RFP 2016-0009 - ADDENDUM 3

COLIGNY REDEVELOPMENT PROJECT

Town of Hilton Head Island, South Carolina

Date Issued: August 5, 2016

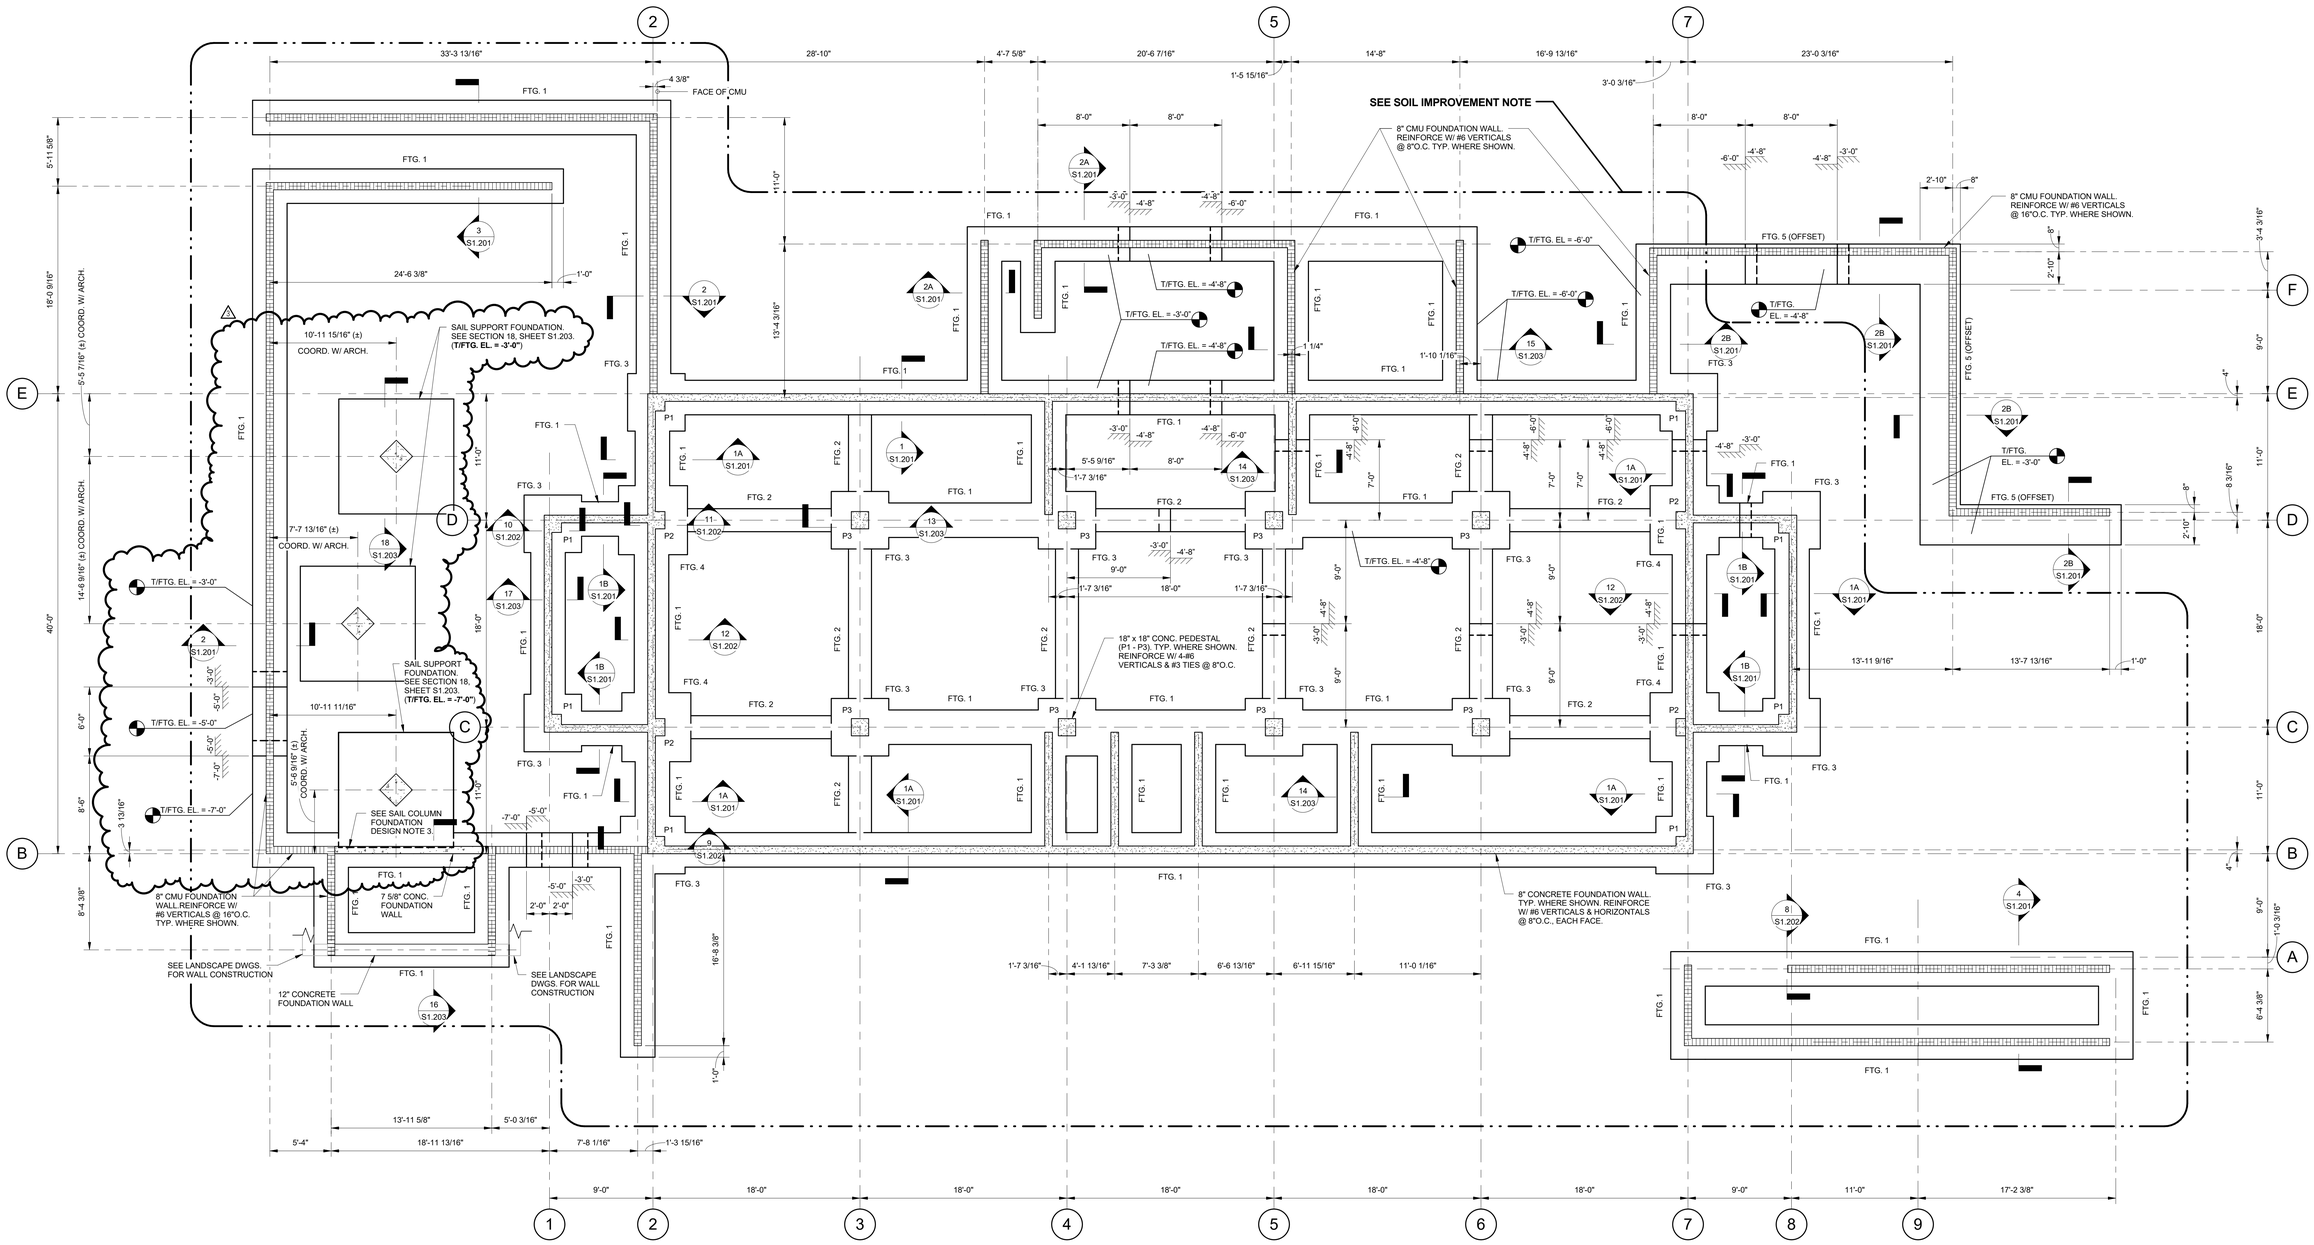
3.25 SHEET S1.100

A. Added sail foundations and notes

SECTION 15
1" = 1'-0" S1.100 | S1.203

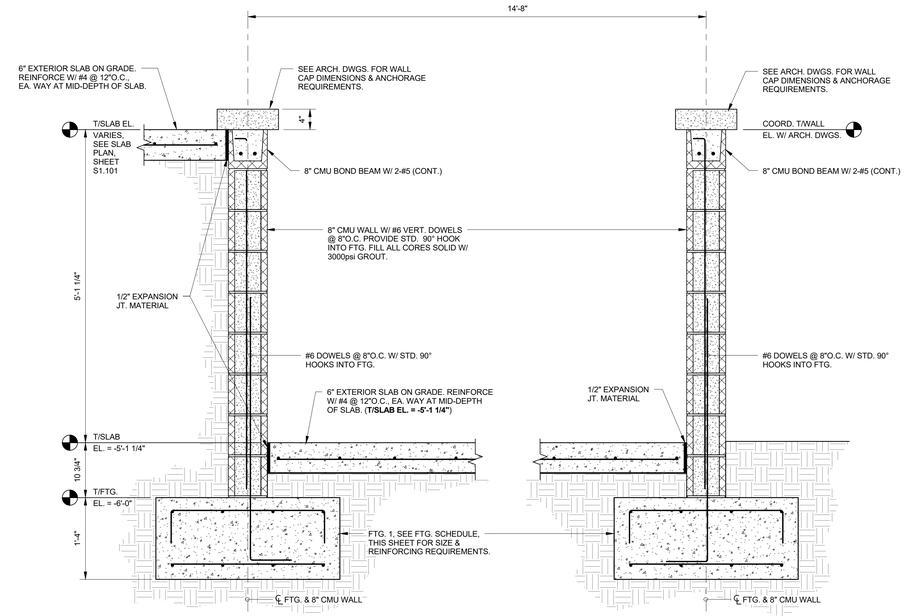
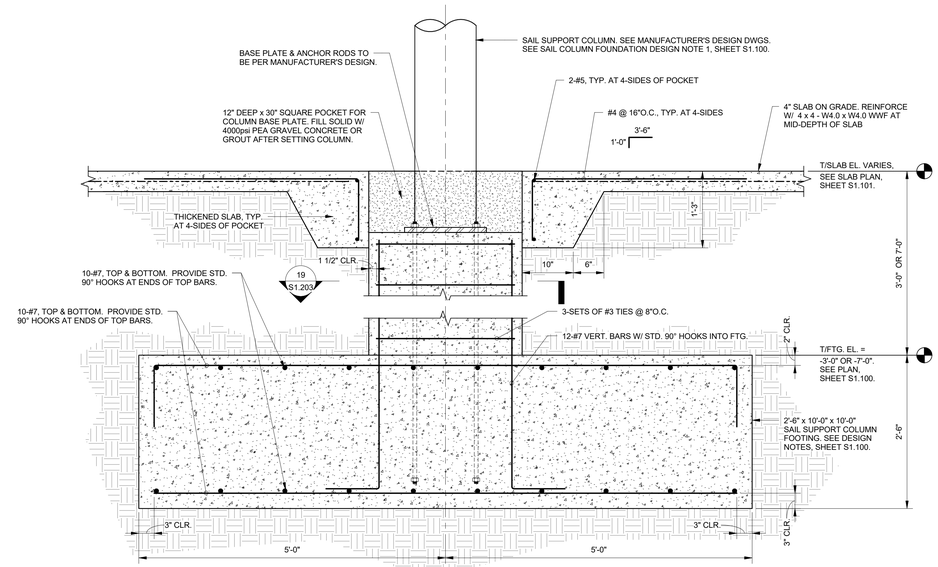
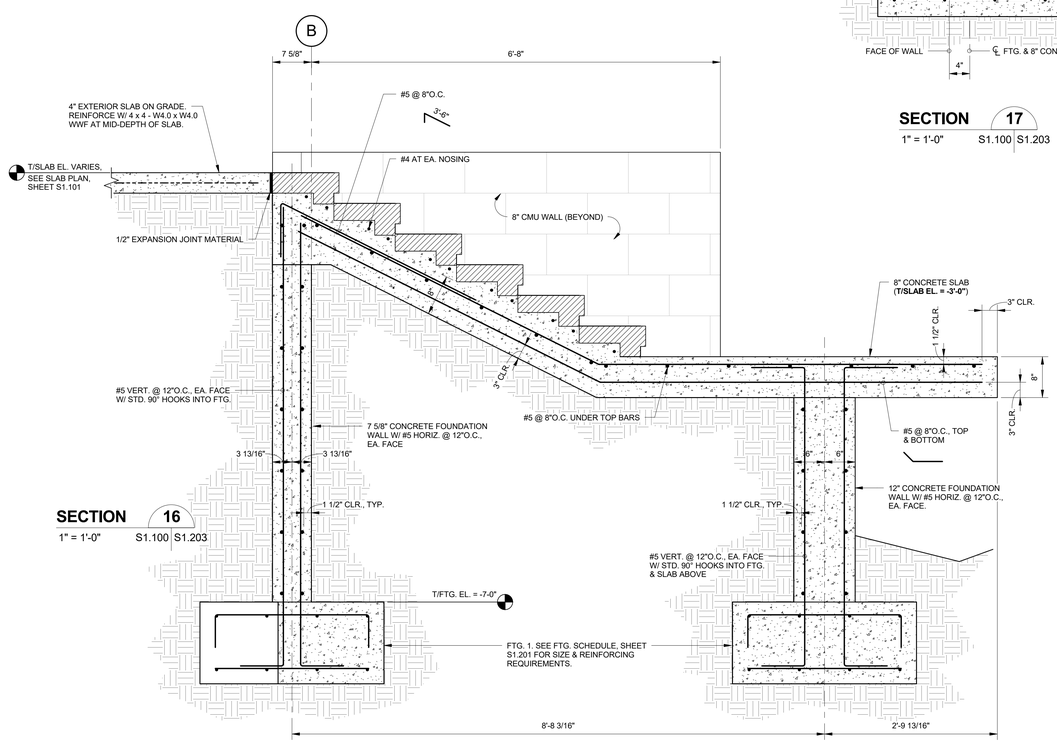
3.28 SHEET S1.203

A. Added details for sail foundations.

1 CHILDRENS MUSEUM POWER & TELECOM. PLAN
E1.101 SCALE: 1/8" = 1'-0"

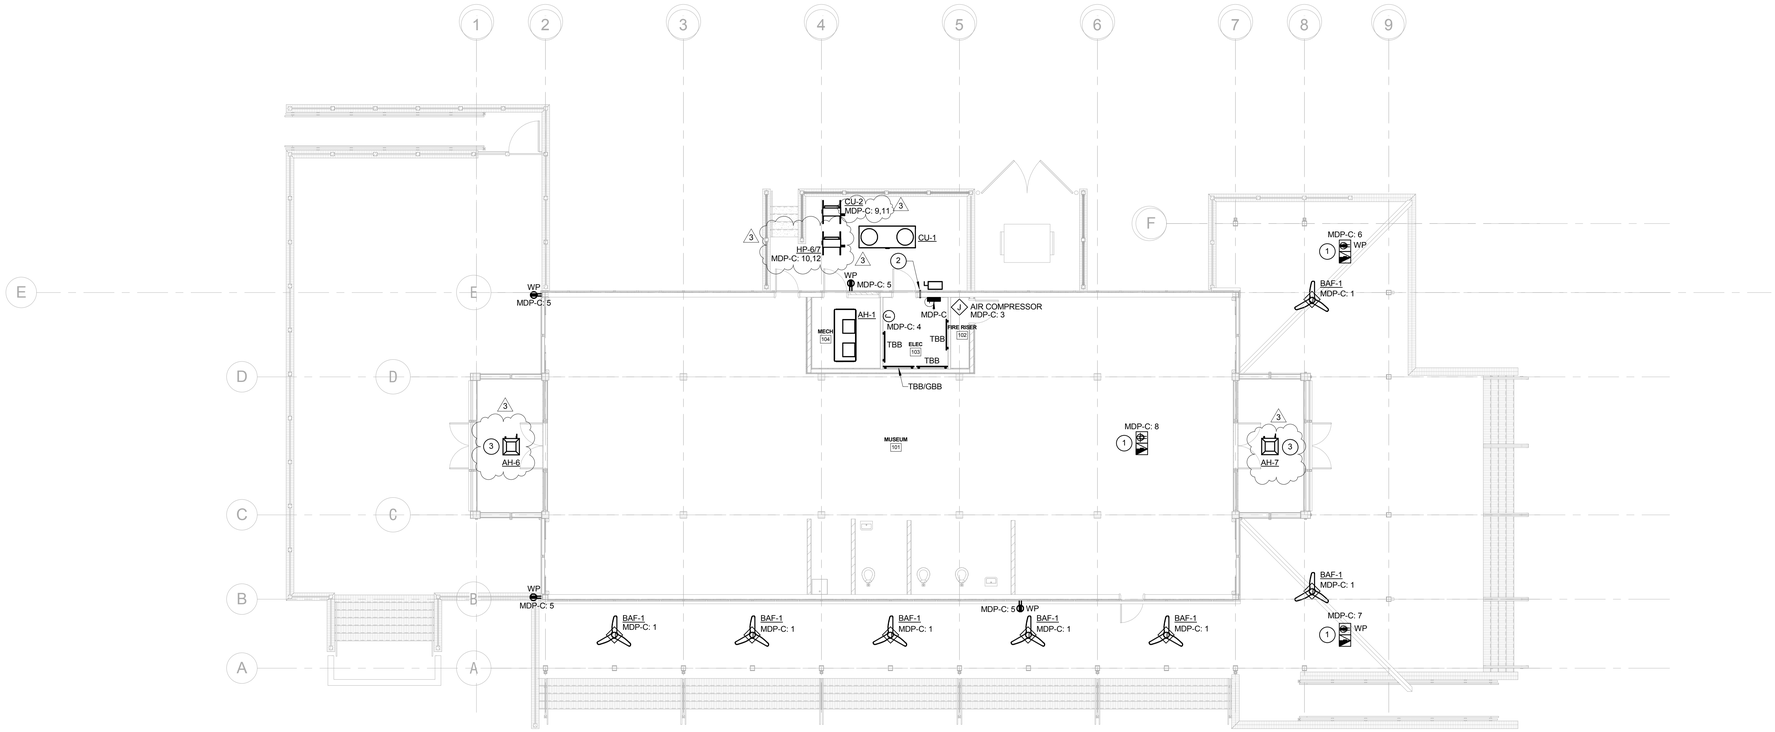
3.32 SHEET E1.101

A. Added power to mini-splits.

1 / E1.102 CHILDRENS MUSEUM LIGHTING PLAN
SCALE: 1/8" = 1'-0"

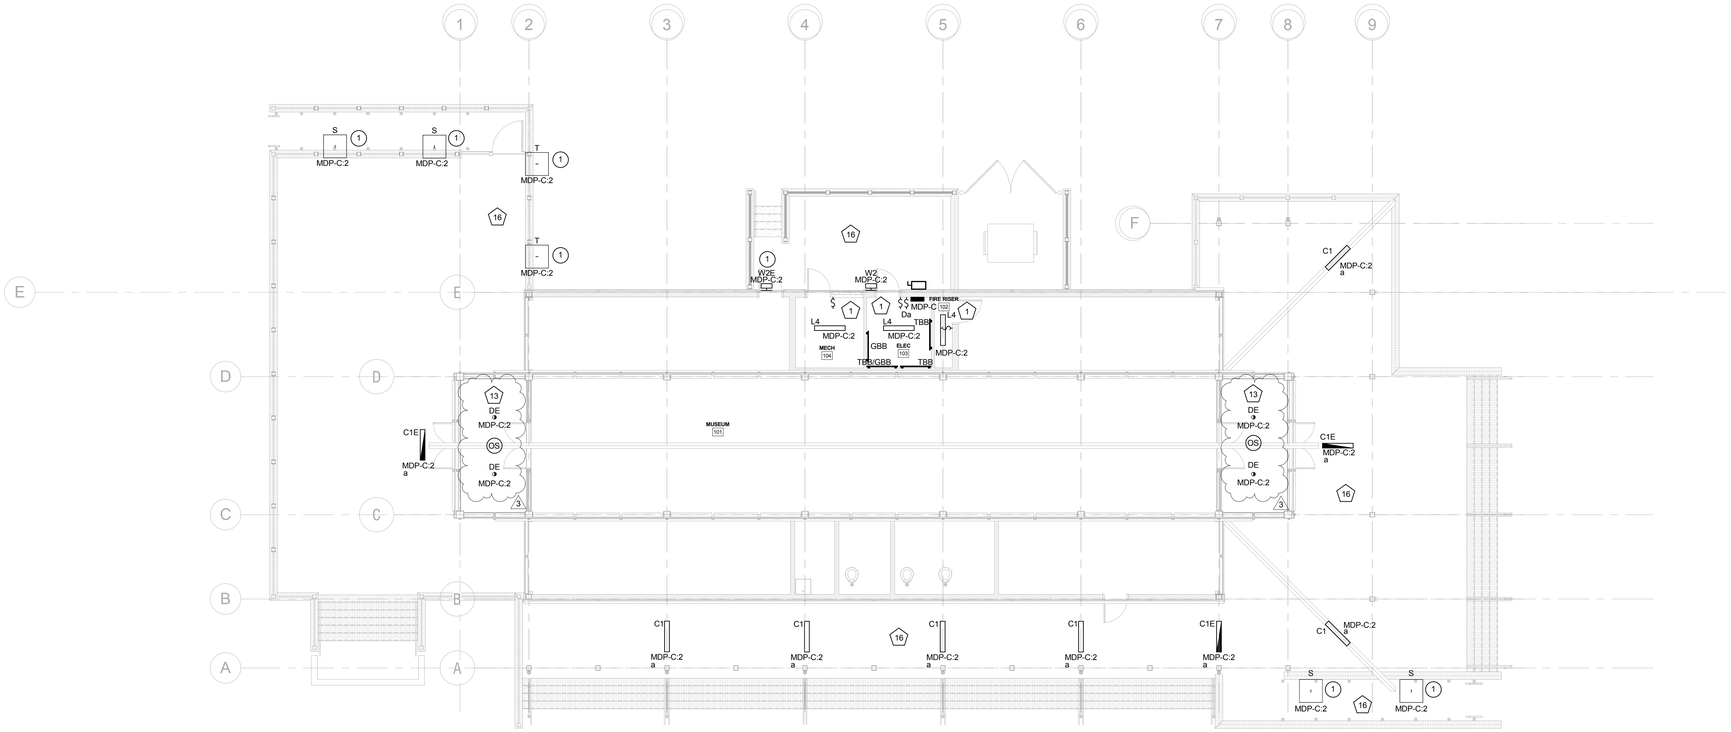
3.33 SHEET E1.102

A. Added lighting in vestibule.

1 FP1.101 MUSEUM FIRE PROTECTION PLAN
SCALE: 1/8" = 1'-0"

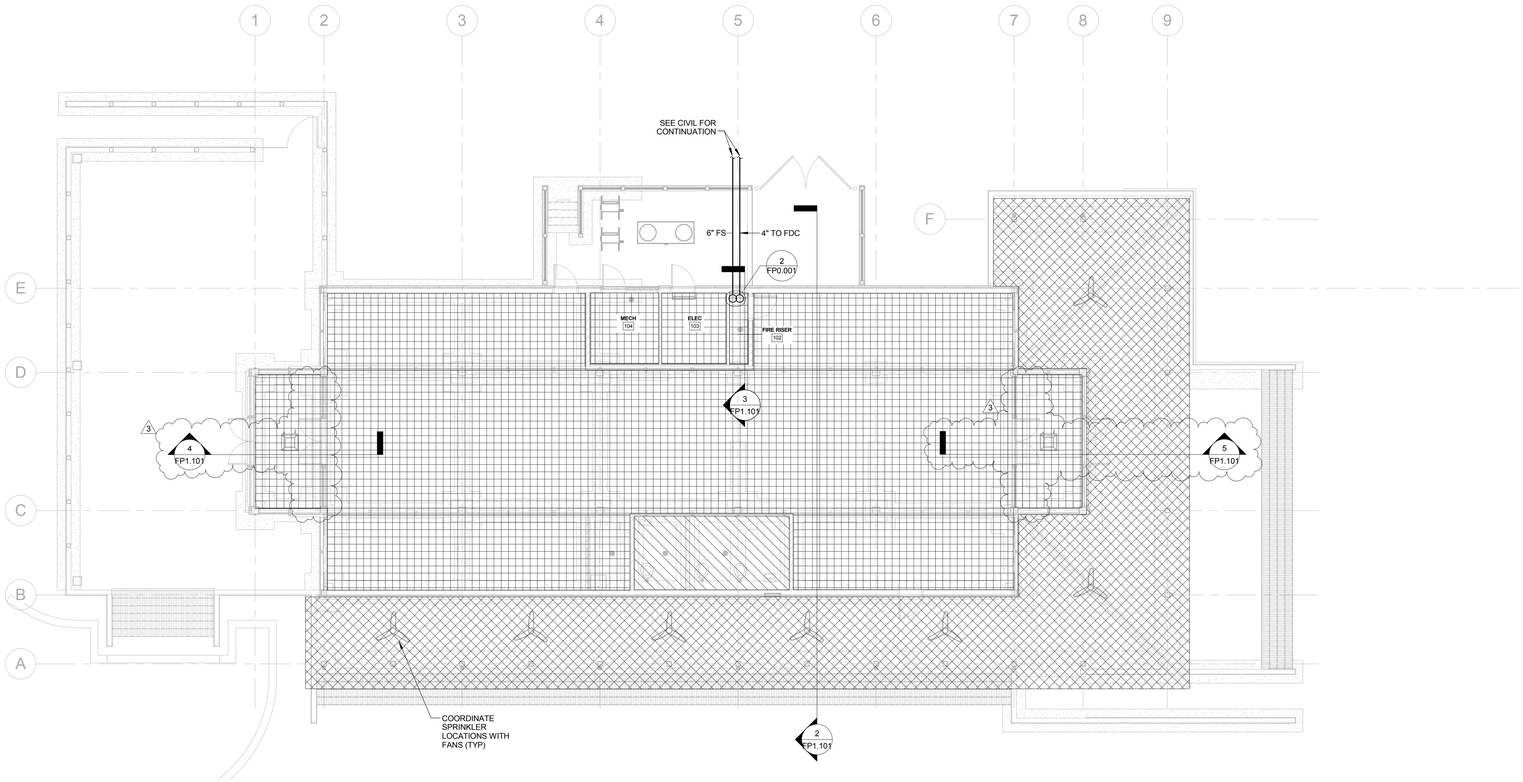
3.34 SHEET FP1.101

A. Added vestibules.
B. Added Sections 4 & 5 showing vestibules.
C. Revised General Notes 2 and 3.

1 M1.101 CHILDREN'S MUSEUM HVAC PLAN
SCALE: 1/4" = 1'-0"

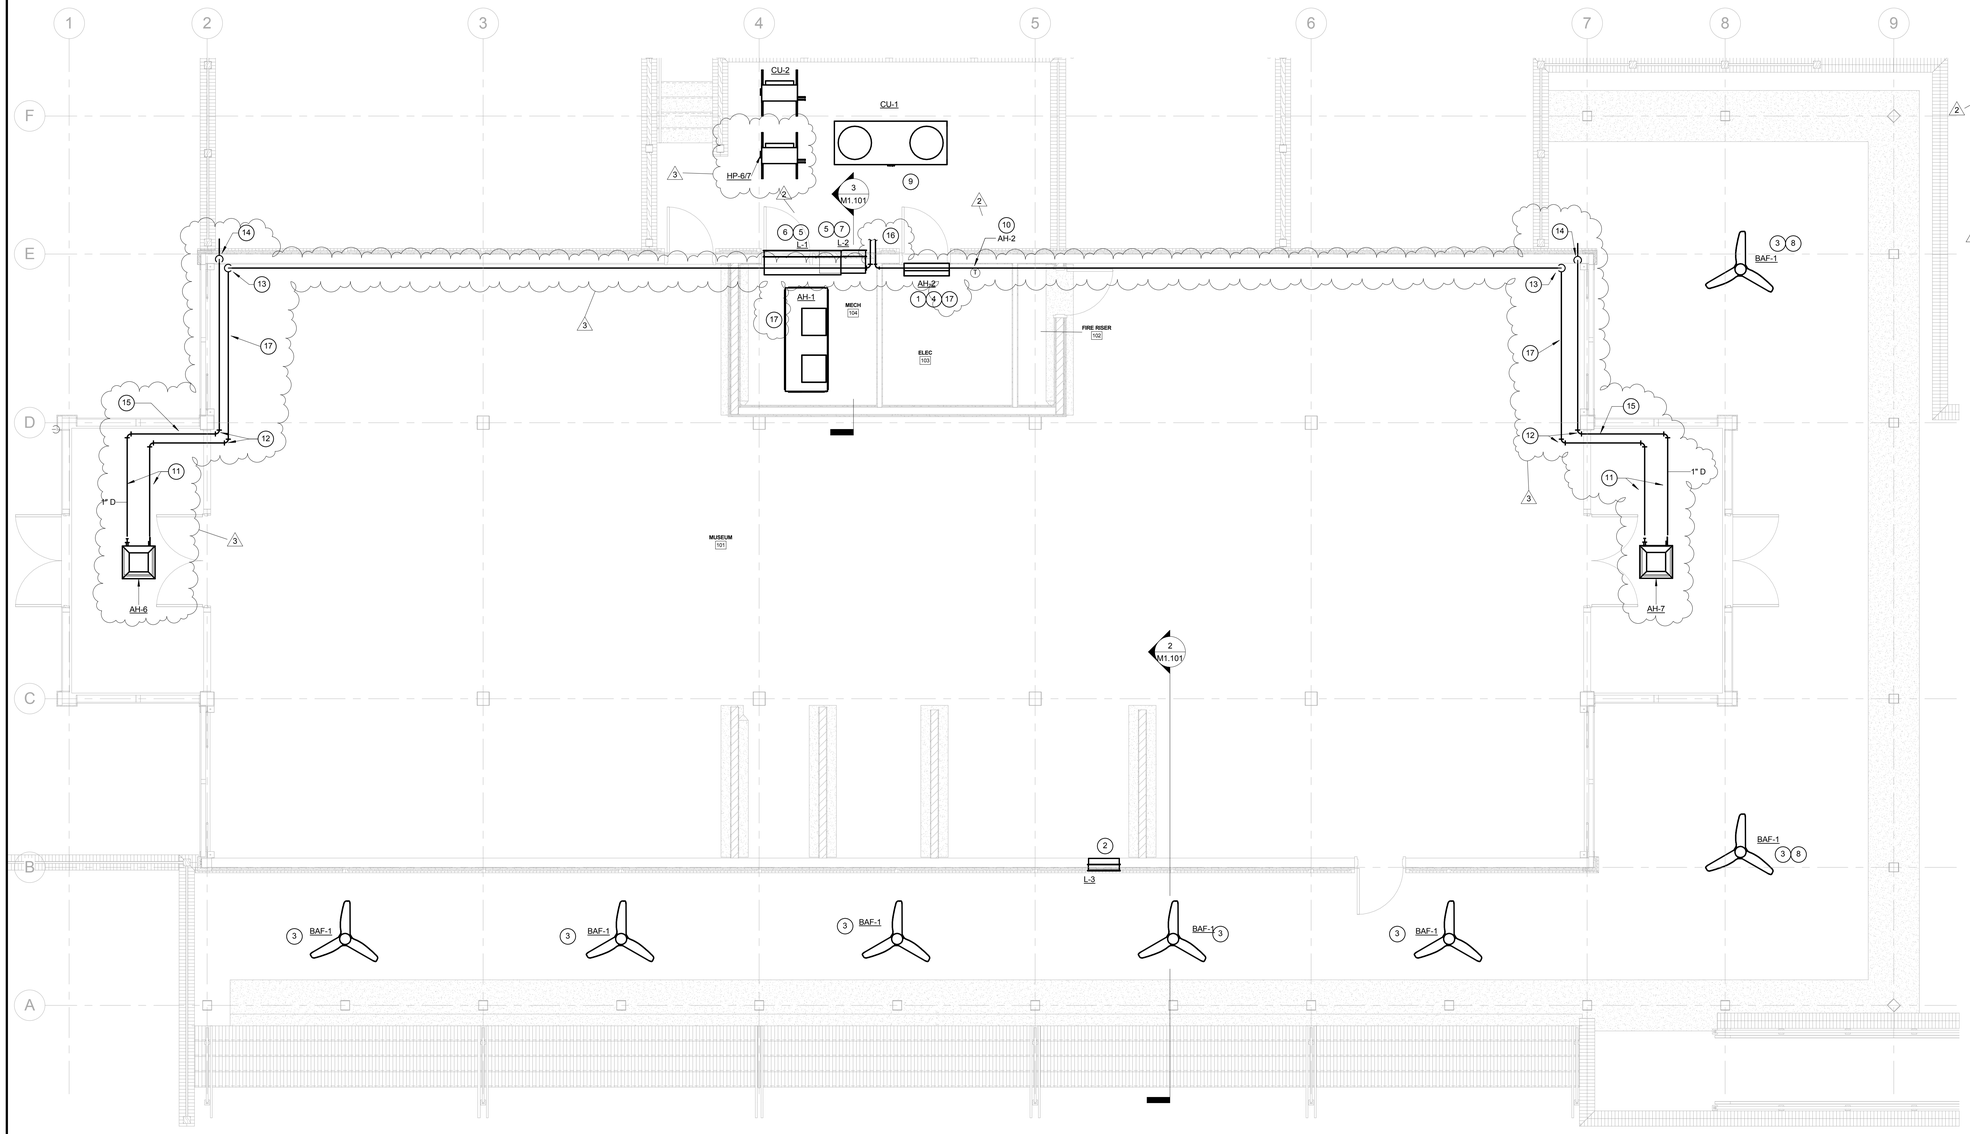
3.37 SHEET M1.101

A. Added AH-6 and AH-7 to vestibules.
B. Added HP-6/7 to enclosure outside.
C. Showed routing for refrigerant and condensate lines serving AH-6 and AH-7.
D. Added Keyed Notes and General Notes.
